**20-ZONE-0117**

**9418 Pirouette Avenue**

**Louisville Metro Planning Commission**

# Requests

# Proposed Plan

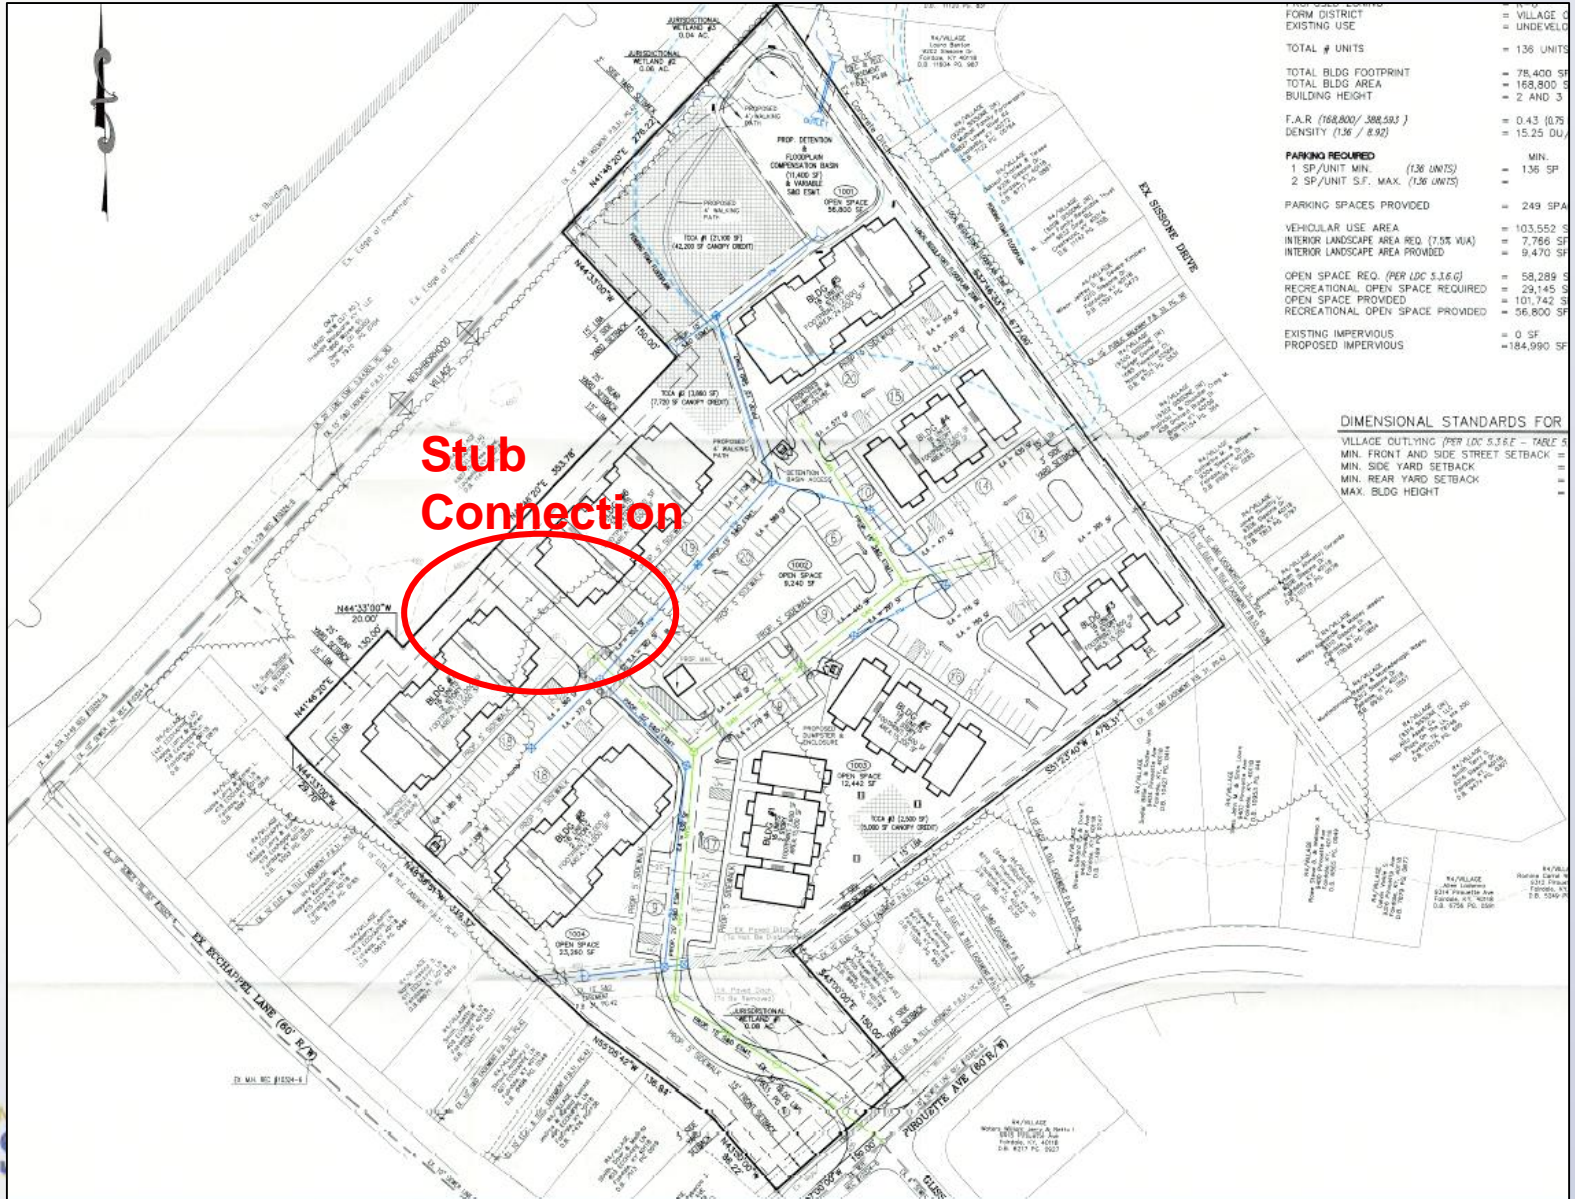
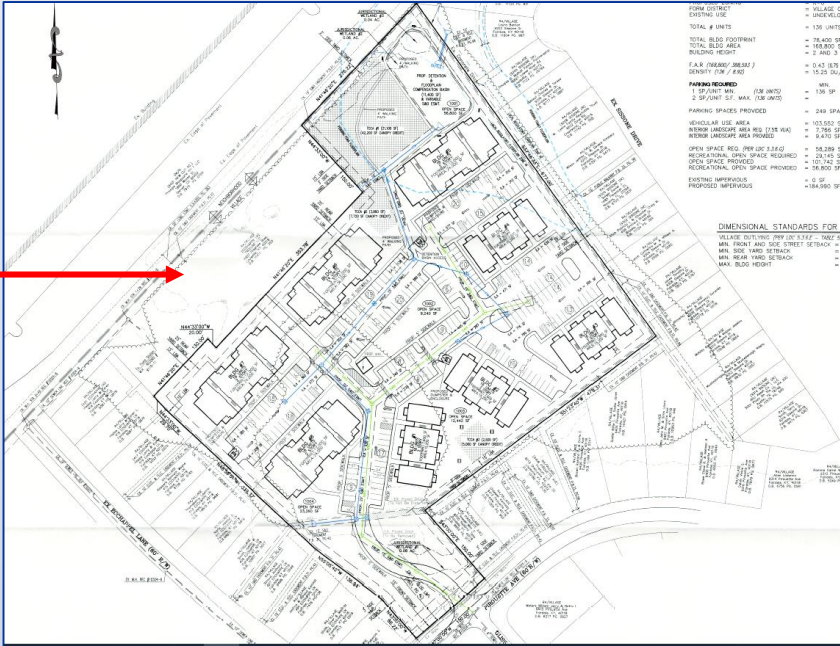
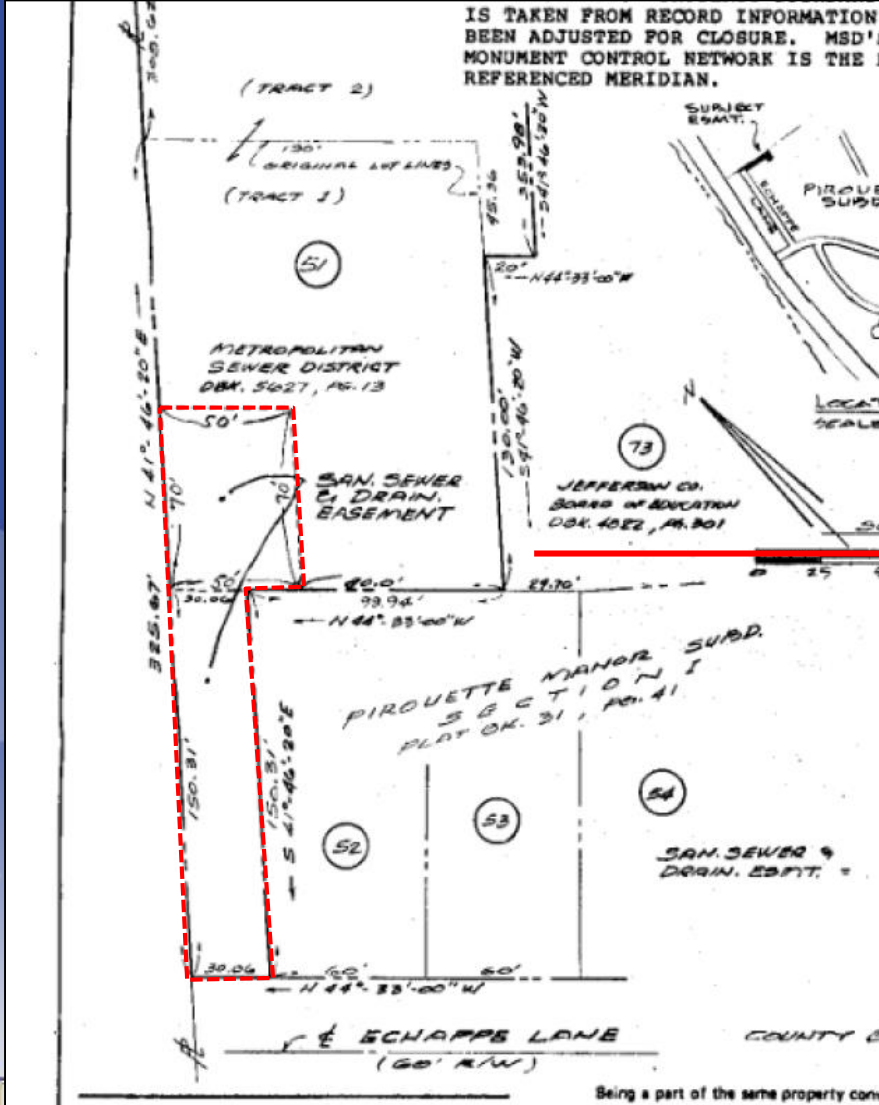
- The waiver and revised detailed district development plan do not appear to be adequately justified based on staff's analysis contained in the standard of review due to the lack of defined roadway connection through the subject site to an abutting property.
